PUBLIC HEARING OF THE NEVADA COUNTY BUILDING & ACCESSIBILITY STANDARDS BOARD OF APPEALS

- Call the meeting to order
- Pledge of Allegiance
- Roll Call
- Approval of minutes from meeting July 8, 2019
- Consider an appeal of a code interpretation from Building Official regarding 2016 California Residential Code R317.1.14 Wood Columns as it relates to permit for a two-story barn for a property located at 16887 Champion Rd, Nevada City, CA, Assessor Parcel Number 004-151-088.
- General discussion regarding Reconstruction Policy #BD-CSC-08-002
- Public Comment
- Adjourn

Appeal for a Technical Interpretation of the Building Standard Codes Project Location: 17688 CHAMPION RD. NEVADA CITY Type of Construction: V-B Woos FRANE Occupancy Type: R3 RESIDENTIAL Building Permit Number (if applicable): 181444 Name of Property Owner(s): Swift MERRIT TRUST Phone #: Email: Property Owner Address: (Attach construction plans, application for permit and other relevant information) In accordance with the provisions of Section L-V 2.2 of Chapter V of the Nevada County Land Use Code I hereby apply to the Board of Appeals for an interpretation of Section R317.1.4 , of the CALIFORNIA RESIDENTIAL Code which

THE DECK IN QUESTION, HOW THE CONCERNS HAVE BEEN ADDRESSED

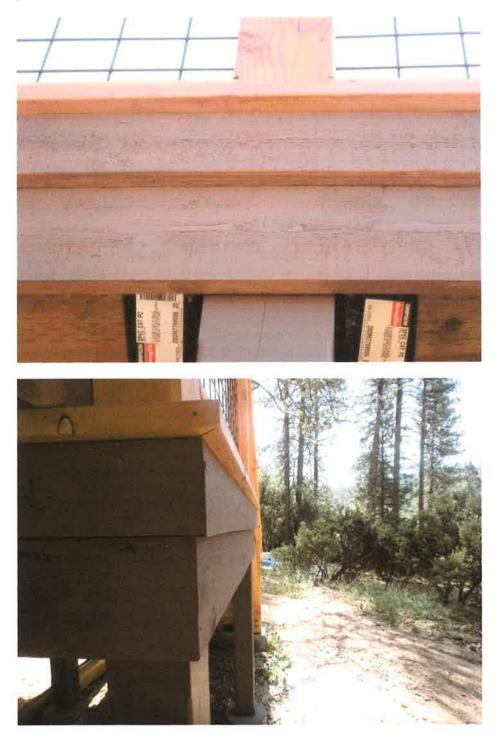
36 posts are subject to the ruling.

Every post is elevated on the concrete piers

Every post is set on a metal stand-off base.

A concrete slab will extend past the piers.

The tops of the posts are protected, not subject to decay by water absorption. The upper level posts are overlapped by the rail cap 1", the lower posts have 3 layers of material providing 2 ½" of overhang protection. All of these materials, (Rail cap, Fascia , decking), are cedar, an approved species for decay resistence.

This joint is the only location that is subject to water getting places it shouldn't.

A metal flashing can be provided to prevent infiltration, protect against decay.

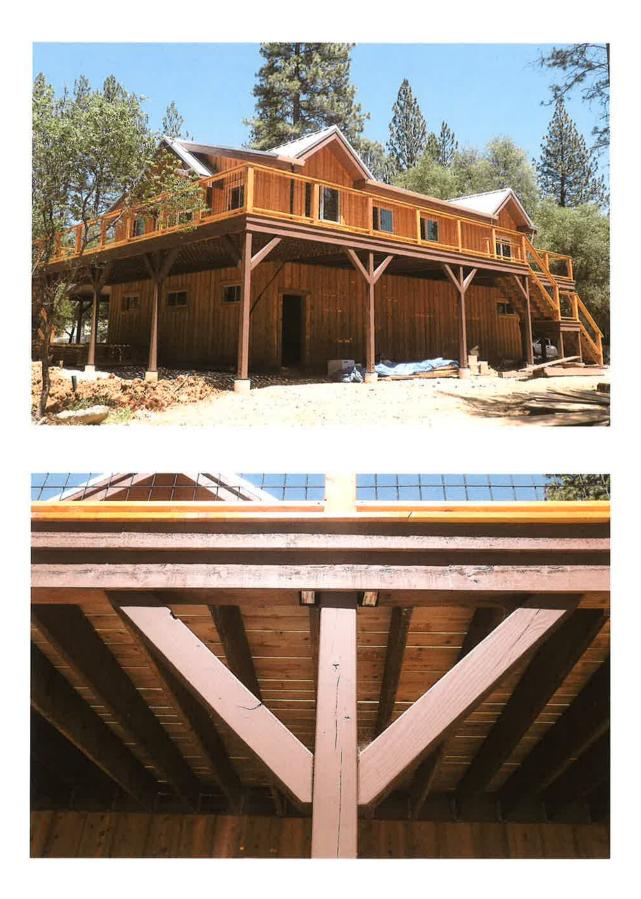
On sheet S-001, under Wood Construction (Carpentry), note 9 indicates that posts shall be pressure treated when exposed to weather.

Reference the California Residential Code, Section R317.1.4. According to exception number 3 the deck posts are not required to be pressure treated if the wood posts are not within 6" of finished grade and are installed on a 1" standoff above the concrete pedestal. The posts on this project meet these requirements and are not required to be pressure treated.

All horizontally framed deck elements have been installed as either pressure treated lumber or cedar. The posts and knee braces are the only elements of the deck that are not pressure treated. Water will not accumulate on the posts because they are vertical elements. The knee braces are nearly vertical elements and will not accumulate water either. The joint between the knee brace and the post may accumulate water, therefore we recommend that flashing be installed to mitigate water from accumulating at that connection.

In addition to the above referenced code exception, the posts and knee braces have been treated with preservative stain. It is our professional opinion that the posts and knee braces do not need to be pressure treated.
